# CEDVICE DILL ETIM

MAINTENANCE OF WAY EQUIPMENT								
DATE:	2-28-200	)2		BULLETIN NO:	02-006			
TITLE:	TRAVEL CIRCUIT UPGRADE SERVICE GROUPS D1532WAC Travel Circuit Upgrade Kit H4548WAA Pressure Switch Relay Kit							
RATING:		<b>DIRECTIVE</b> (Action Is Required)		ALERT (Potential Problem)				
		INFORMATION (Action Is Optional)	X	PRODUCT IMPROVEMI (Enhance Product)	ENT			
PRODUCT SI	ERIES / M	ODEL: TR10 Tie Excha	anger					
SERIAL NO:	All TR10 Phase III Models Serial # 5580819 and Higher							
SIIMMADV:	HTT has	discovered that the speed	l in the D	A numn travel assist valve	may etick

FIGURE 1
TRACTION ASSIST PRESSURE SWITCH HYDRAULIC CIRCUIT

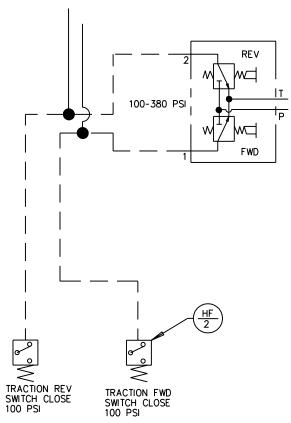
- 1. See Figure 1. Disconnect the electrical cable and hydraulic line from the existing traction forward pressure switch. Remove the existing pressure switch and install the new pressure switch (2) in the same location. Reconnect the electrical cable and hydraulic line to the new traction forward pressure switch (2).

FIGURE 2
TRACTION ASSIST DIRECTIONAL VALVE HYDRAULIC CIRCUIT

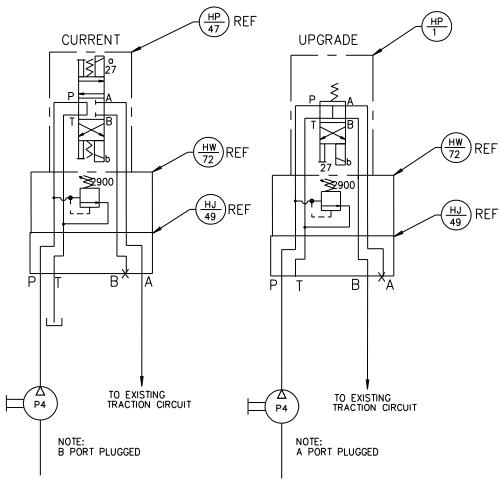
- 2. See Figure 2. Disconnect the electrical cable from the existing traction circuit directional valve. Remove the directional valve from the manifold. Install the new directional valve (1) to the manifold. Reconnect the electrical cable to the new traction circuit directional valve (1). Change the hydraulic line from port A to port B and the plug from port B to port A in the direction valve manifold.

- 1. INSTALL NEW FORWARD TRAVEL PRESSURE SWITCH ITEM 2 IN THE SAME LOCATION
- 2. INSTALL NEW VALVE ITEM 1
- 3. CHANGE PORT A AND PORT B PLUMBING

FIGURE 4
NEW TRACTION ASSIST CIRCUIT ELECTRICAL SCHEMATIC

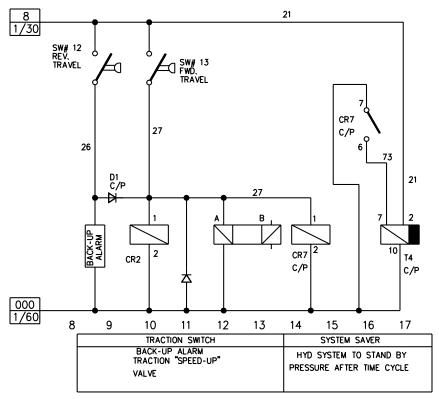
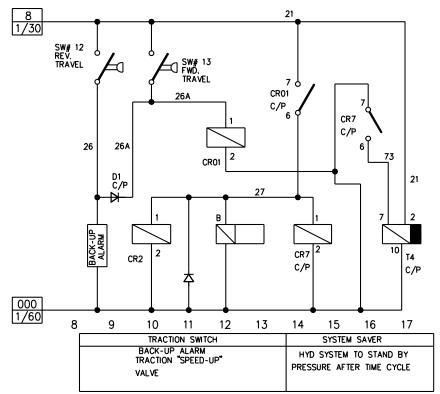
- 3. Reference the existing traction circuit electrical schematic Figure 3 and the new traction circuit electrical schematic Figure 4 when making electrical changes.

# FIGURE 5 TRACTION ASSIST CIRCUIT INTERCONNECT WIRING

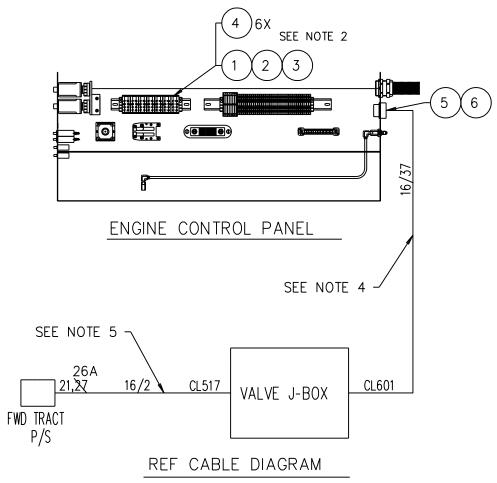
- 4. See Figure 5. Install the relay mount (1) and relay (2) on the engine control panel in the approximate location shown.
- 5. See Figure 6. Remove wire #27 from D1(1) and TSA(18). Install new wire #26A from D1(1) to TSA(34).

- 1 BOLD TEXT REF ADDITION,
- 2 INSTALL ITEM 1 & 2 (RELAY MOUNT AND RELAY) IN APPX AREA, AND REF "ENGINE CONTROL PANEL WIRING".
- 3 REMOVE WIRE 27 FROM D1(1) AND TSA(18).
  INSTALL NEW WIRE 26A FROM D1(1) TO TSA(34).
- 4 INSTALL WIRE 26A IN THE PI AND SOCKET OF CL601 AND RECEPT. ON PIN(25). CONNECT WIRE 26A TO THE ENGINE CONTROL PANEL TSA(34) AND VALVE J-BOX TSA(39).
- 5 REF "VALVE J-BOX WIRING" AND REMOVE WIRE 27 IN CL517 TSA(8). RENUMBER THIS WIRE TO 26A AND CONNECT TO NEW TERMINAL 26A TSA(39). ALSO CHANGE WIRE 27 TO 26A ON OPPOSITE END OF CL517 IN THE FOWARD TRACTION PRESSURE SWITCH.

FIGURE 7
ENGINE JUNCTION BOX WIRING

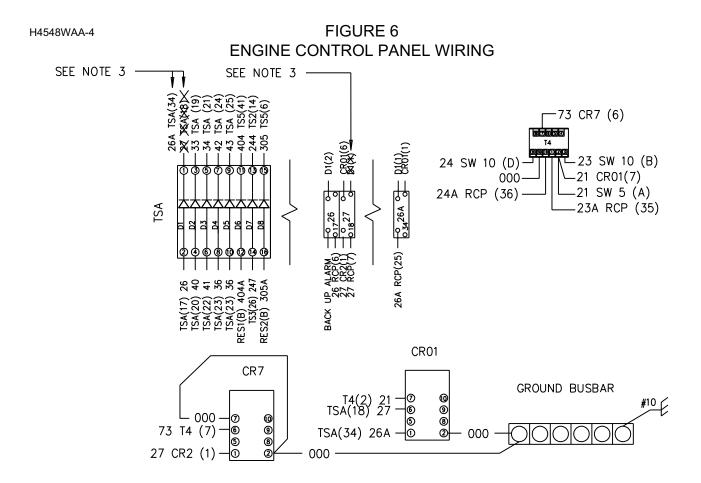
- 6. See Figure 5 and Figure 7. Install wire #26A in the PI and socket of CL601 and receptacle on pin (25). Connect wire #26A to the engine control panel TSA(34) and valve j-box TSA(39).

- 7. See Figure 5 and Figure 7. Remove wire #27 in CL517 TSA(8). Renumber this wire to 26A and connect to new terminal 26A TSA(39). Also change wire #27 to #26A on opposite end of CL517 in the forward traction pressure switch.
